# IMPROVING ACCESS TO TRANSIT USING ROAD SAFETY AUDITS: FOUR CASE STUDIES

U.S. Department of Transportation  
Federal Highway Administration

<b>1. Report No.</b> FHWA-SA-16-120	<b>2. Government Accession No.</b>	<b>3. Recipient's Catalog No.</b>
<b>4. Title and Subtitle</b>  Improving Access to Transit Using Road Safety Audits: Four Case Studies		<b>5. Report Date</b> October 2016
		<b>6. Performing Organization Code</b>
<b>7. Author(s)</b>  Elissa Goughnour, Javier Revilla, and Corey Pitts		<b>8. Performing Organization Report No.</b>
<b>9. Performing Organization Name and Address</b>  Vanasse Hangen Brustlin, Inc. 8300 Boone Boulevard, Suite 700 Vienna, VA 22182-2626		<b>10. Work Unit No. (TRAIS)</b>
		<b>11. Contract or Grant No.</b>
<b>12. Sponsoring Agency Name and Address</b>  Federal Highway Administration Office of Safety 1200 New Jersey Ave. S.E. Washington, DC 20590		<b>13. Type of Report and Period Covered</b>  Final Report October 2016
		<b>14. Sponsoring Agency Code</b>

**Figure 7.** Focus area in the Orlando, FL area (West Colonial Drive and North Pine Hills Road) showing possible intersection improvements (Map data: ©Google).

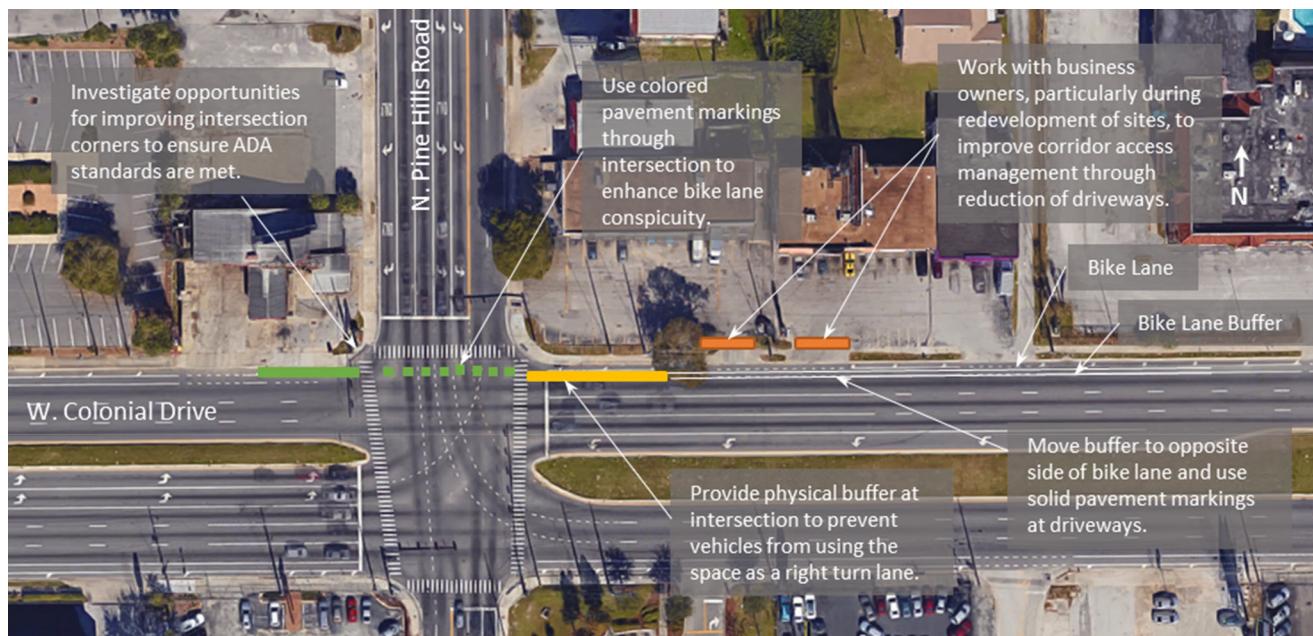
*Increased separation of modes.* Consider alternatives to provide physical separation of motorized vehicles from bicyclists and pedestrians. In Orlando, Florida, at the intersection of West Colonial Drive and North Pine Hills Road, drivers were using the bike lane and buffer as a right turn lane and were also encroaching on crossing pedestrians in the crosswalk. Moving the buffer so that it is placed between the bike and travel lanes would provide bicyclists additional separation from motorized vehicles. Additionally, at intersections, a physical barrier in the buffer could be used to prevent vehicles from using this space as a turn lane and would reduce the pedestrian crossing distance. As shown in the example in Figure 7, alternative designs that provide additional protection to non-motorized users are recommended.

**Figure 8. Patton Avenue road diet concept diagram (Map data: ©Google).**

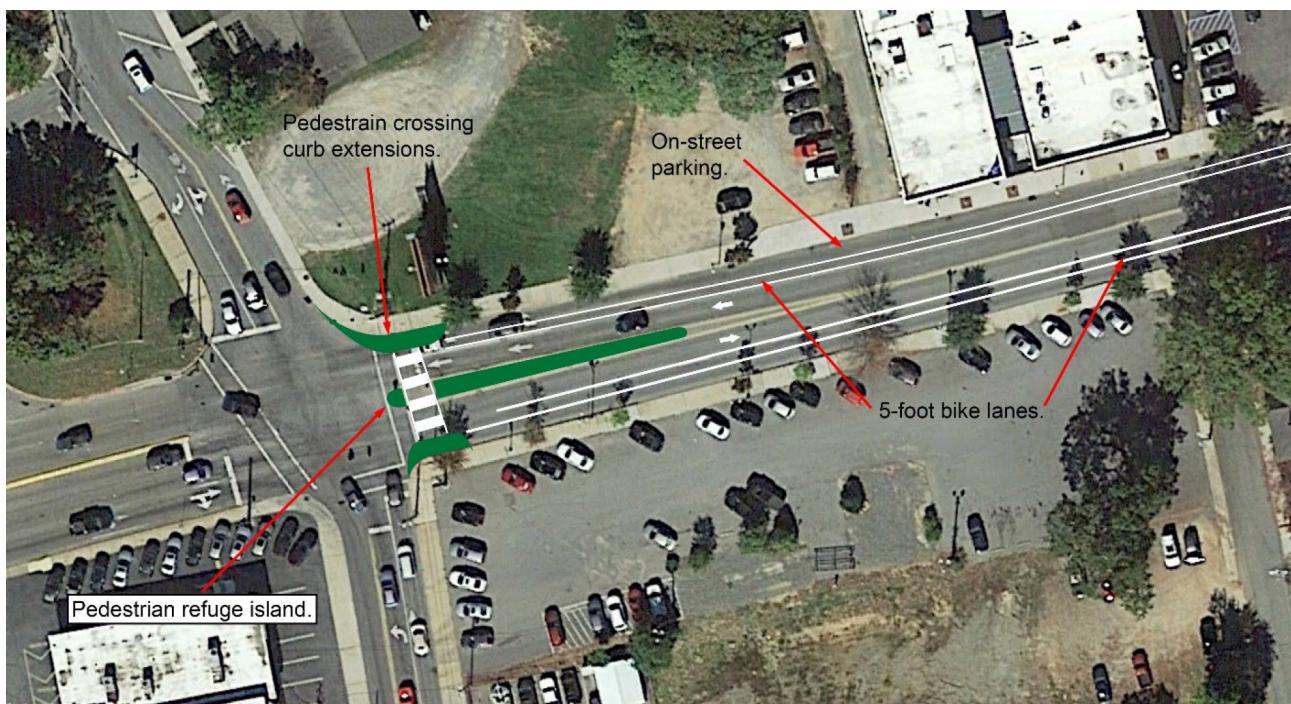
Figure 8 shows how a road diet could be implemented on Patton Avenue in the City of Asheville, starting at the entrance to the city. At Clingman Avenue, one traffic lane could be removed to allow for on-street parking and a bike lane as displayed in. This would provide several benefits:

- A narrower cross-section would make it easier for pedestrians to cross Patton Avenue.
- Space could be provided for a designated bike lane and on-street parking.
- Narrowing of the roadway would provide traffic calming and could potentially reduce the frequency/severity of crashes.
- Pedestrian refuge island at the intersection with Clingman Avenue provides a refuge for pedestrians as well as indications to drivers of the change in roadway conditions from suburban to urban.
- Designate bus-pullout bays could be used to minimize traffic disruption on Patton Avenue.

**Above:** diagram showing the curb extensions on East Alameda Street and North 6th Avenue (Map data: Microsoft® Bing™).

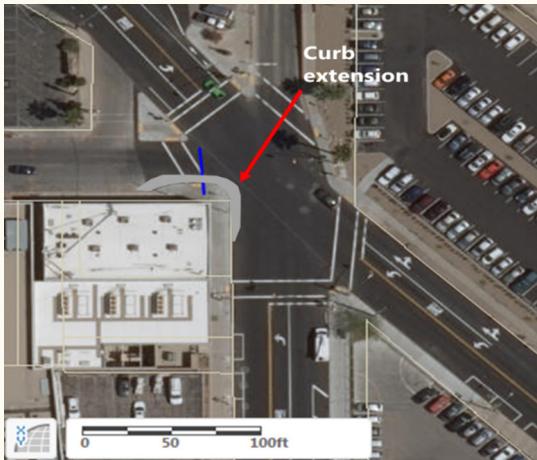
**Confusing Pedestrian Signs.** Signage has been installed, alerting both drivers and pedestrians to watch for each other when turning or crossing the street. The signage intended for pedestrians is a black and white sign informing them to "Watch for Turning Traffic". This message was considered confusing to pedestrians because it is not a typical application of the sign.

**Curb Extension.** Reduce the pedestrian crossing distance and improve visibility of pedestrians at the intersection by extending the existing curb extension on East Alameda Street and adding a curb extension on the southwest corner of the intersection along North 6th Avenue. Any reconfiguration of the curb line should consider future bicycle infrastructure designs that may be installed along East Alameda Street.

**Modify Pedestrian Warning.** Replace existing black and white "WATCH FOR TURNING TRAFFIC" signage with yellow warning sign and consider alternative warning methods such as adding pavement marking warnings for pedestrians to watch for turning vehicles.

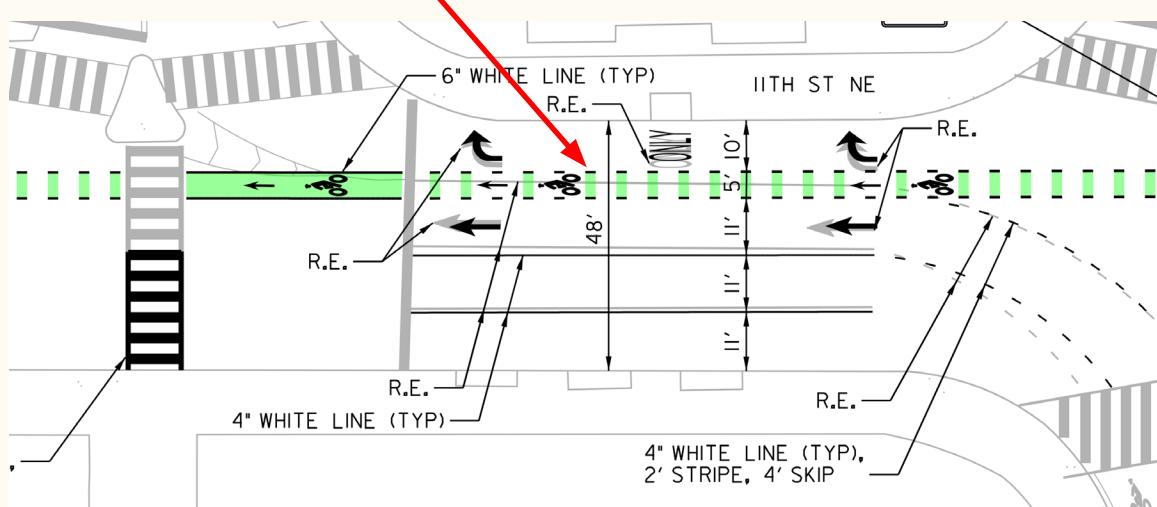
**Atypical Traffic Signalization.** The City utilizes a flashing yellow arrow to alert drivers to make the left turn cautiously, and look for pedestrians. This indication is given for northbound drivers at the same time the opposing drivers are seeing a red indication. This type of application is atypical of standard industry practices, and is not applied anywhere else in Tucson. This could create a situation where left turning vehicles seeing a flashing yellow arrow do not expect to encounter opposing traffic.

**Bike Lane Intersection Conflicts.** There are bike lanes along the western leg of East Toole Avenue that transition to shared lane markings to the east of North 6th Avenue. The size and geometry of the intersection create a situation where it is not clear how cyclists should travel through the intersection. "Watch for Turning Traffic". This message was considered confusing to pedestrians because it is not a typical application of the sign.

**Signal Modification.** Replace the non-standard flashing yellow arrow with a green ball and supplement the traffic signal with the appropriate static or illuminated signage R10-15 alerting drivers to the presence of pedestrians.

**A wheelchair user accessing the same shopping center by using the driveway (Photo credit: Elissa Goughnour).**

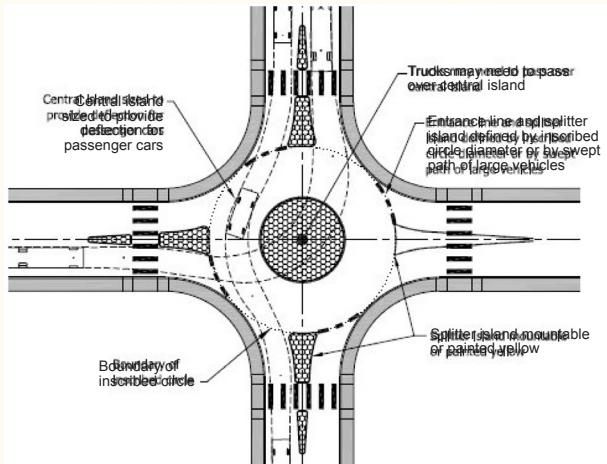
**Lack of accessible paths from bus stop to neighboring destinations.** There were pathways worn into the grass, indicating the path that pedestrians travel from the transit stop to neighboring destinations.

**Accessible routes.** Work with business owners to encourage and determine the feasibility of adding accessible paths to their businesses. A separate pathway would provide direct access for pedestrians rather than requiring them to use the driveway alongside motorized vehicles.
